Proposed alterations & additions at 51 Grandview Drive, Lot 26, D.P. 16029, in Newport, NSW

Stage 3 (Detailed design) Road Safety Audit

May 2020

Table 4.4: Road safety audit findings

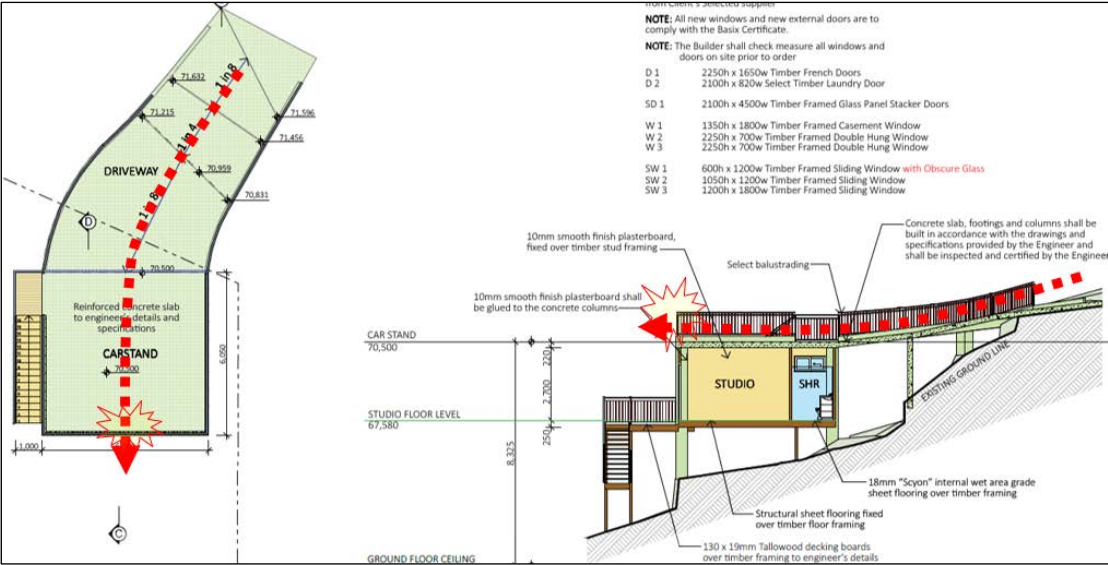
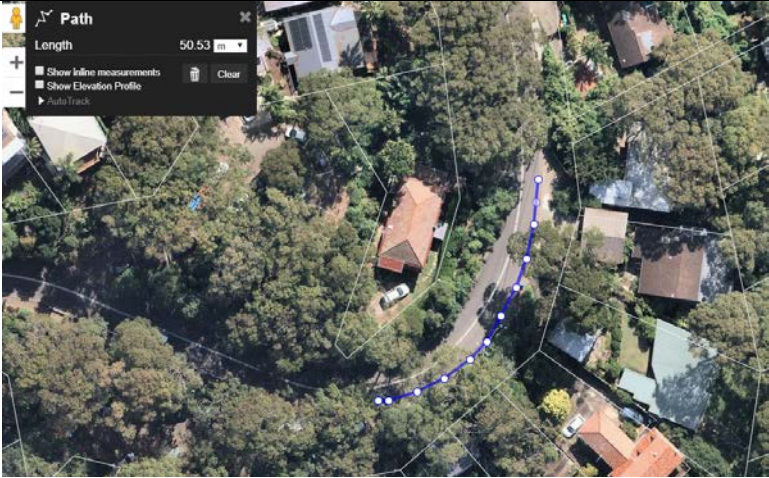
No.	Drawings / Approximate Location	Description of findings	Risk rating (likelihood/severity)
1	DA 03 / Car stand	<p>The design does not propose guardrail safety barriers to stop an errant vehicle from running over the edge and falling into a drop behind the parking space (refer to Figure 4.1). Also, there is no wheel stop proposed on the edge of the car stand, where it is considered necessary to limit the travel of a vehicle into the car stand/parking space.</p> <p>The Auditors also believe that the proposed balustrading is unlikely to stop an errant vehicle, especially considering the downhill Driveway.</p> <p>Consequently, an errant vehicle falling into the drop behind the edge of the proposed car stand could result in severe injury or even death to the occupants.</p> 	High (Improbable / Catastrophic)
